ORIGINATION FORM

Proposed Revisions to a Standard Plans Index

Index Number: 654-001

Index Title: Rectangular Rapid Flashing Beacon Assembly

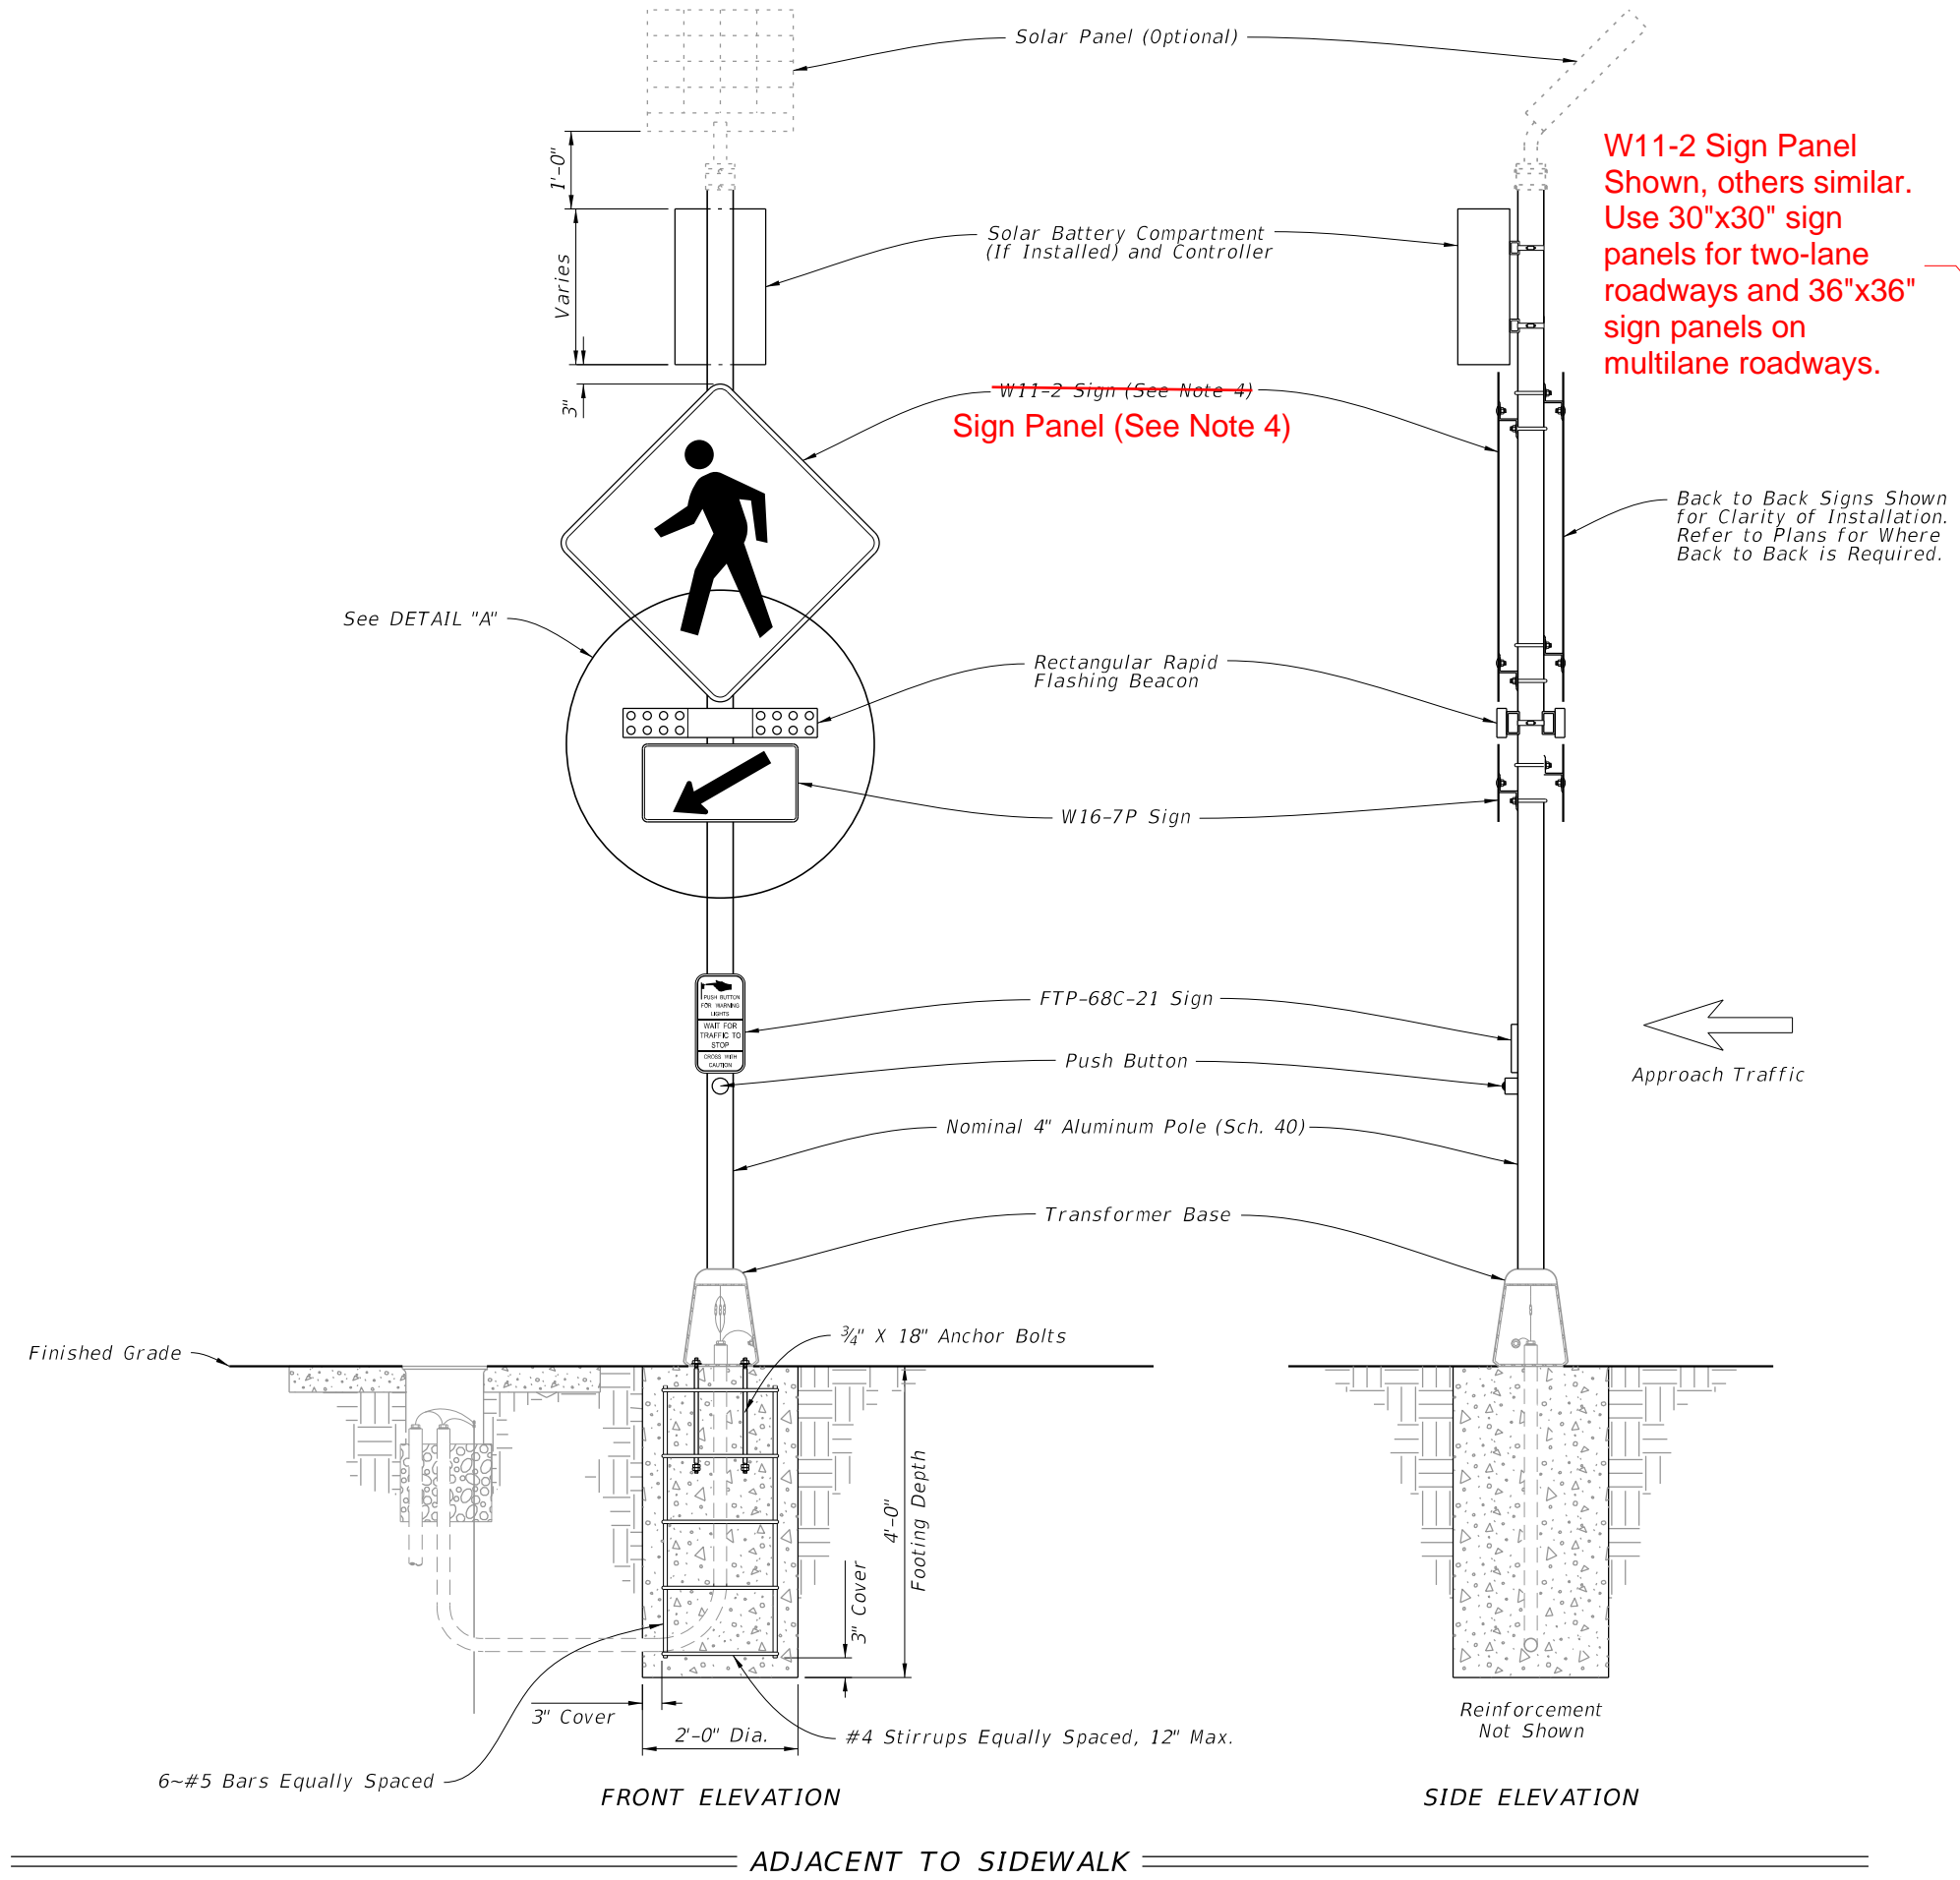
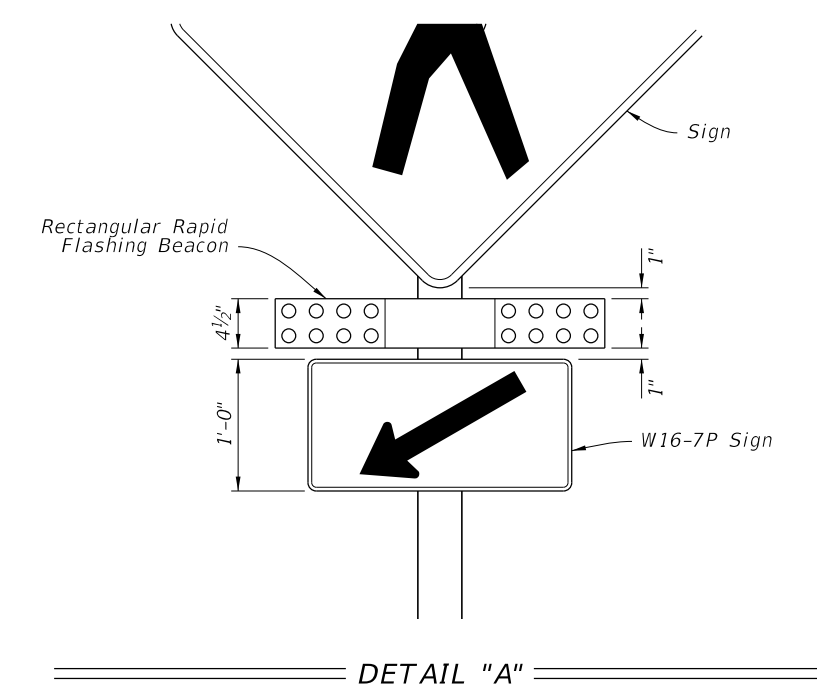
Sheet 1: Updated Note 4 to "W11-2 Sign Panel Shown, others similar. Use 30"x30" sign panels for two-lane roadways and 36"x36" sign panels on multi-lane roadways. Updated callout to "Sign Panel (See Note 4)". Added Note 12, "In lieu of footing design shown, a Spread Footing may be used in accordance with index 700-120."

Note 4 and callouts were updated at the request of the TERL to allow for various sign options.

Note 12 was added because of new spread footing design option in Standard Plans Index 700-120.

W11-2 Sign Panel Shown, others similar. Use 30"x30" sign panels for two-lane roadways and 36"x36" sign panels on multilane roadways.

12. In lieu of footing design shown, a Spread Footing may be used in accordance with Index 700-120.

LAST REVISION 11/01/21	DESCRIPTION: 11/01/23	FDOT	FY 2023-24 STANDARD PLANS	RECTANGULAR RAPID FLASHING BEACON ASSEMBLY	INDEX 654-001	SHEET 2 of 2
---------------------------	--------------------------	------	------------------------------	--	------------------	-----------------

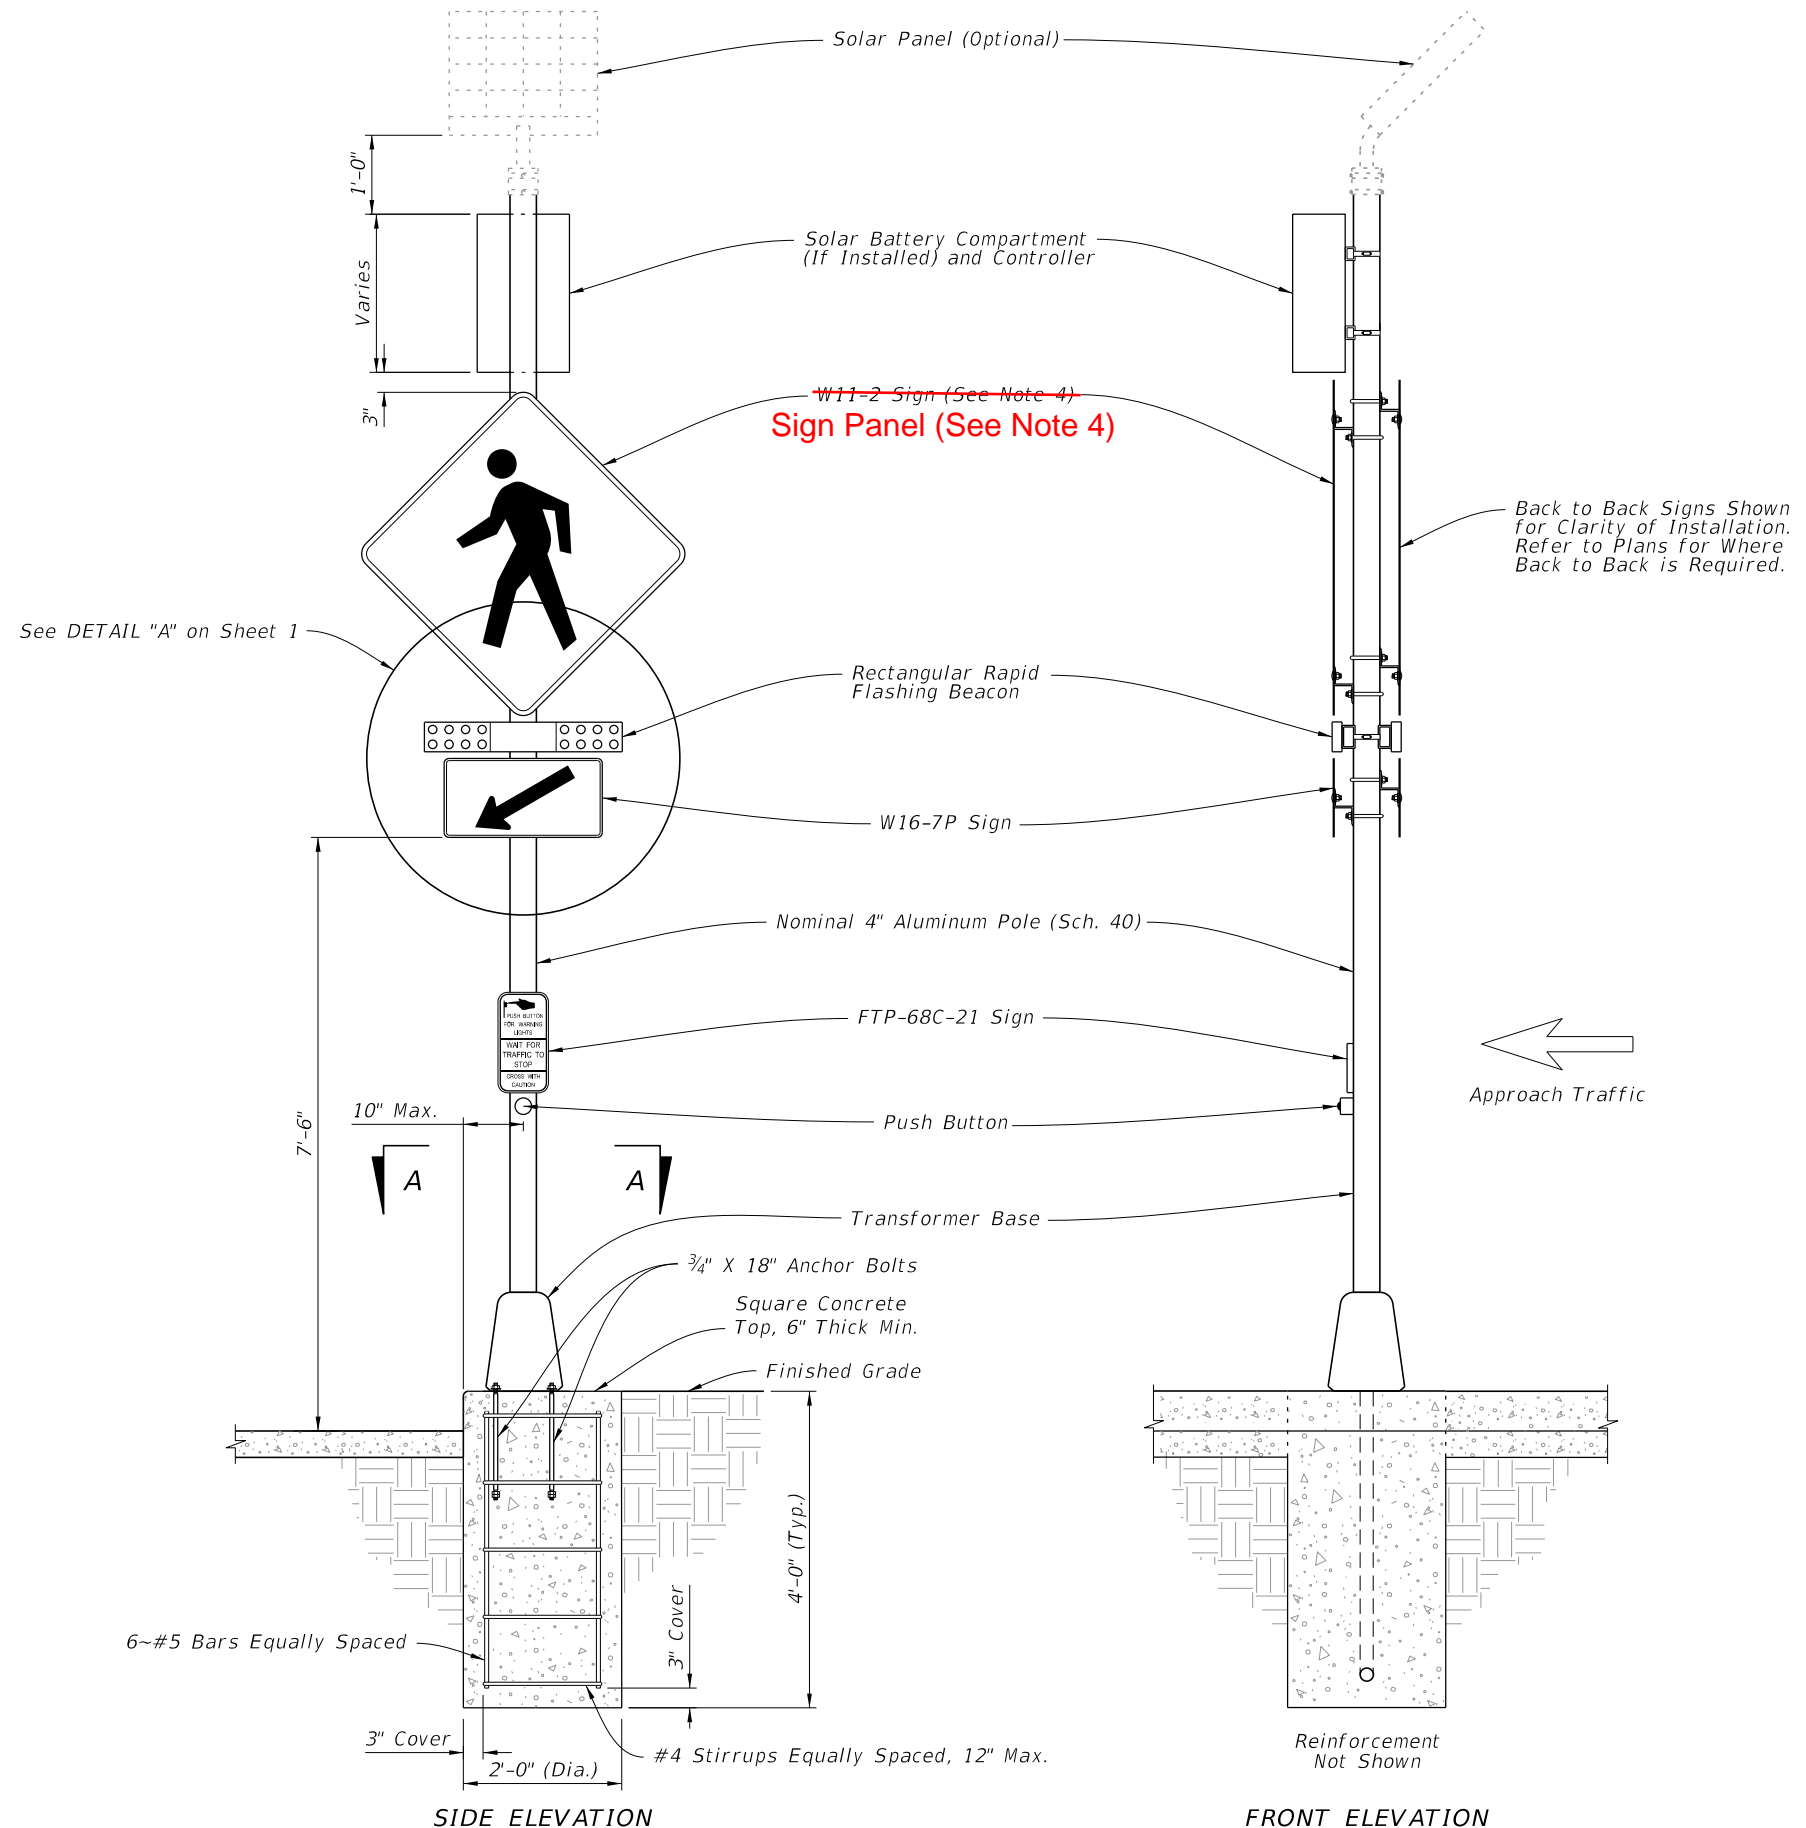
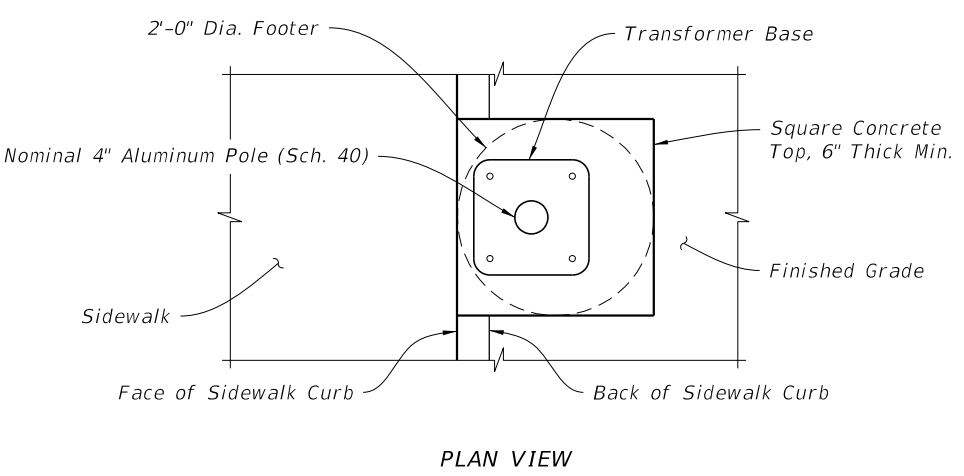
Sheet 2: Updated callout to "Sign Panel (See Note 4)".
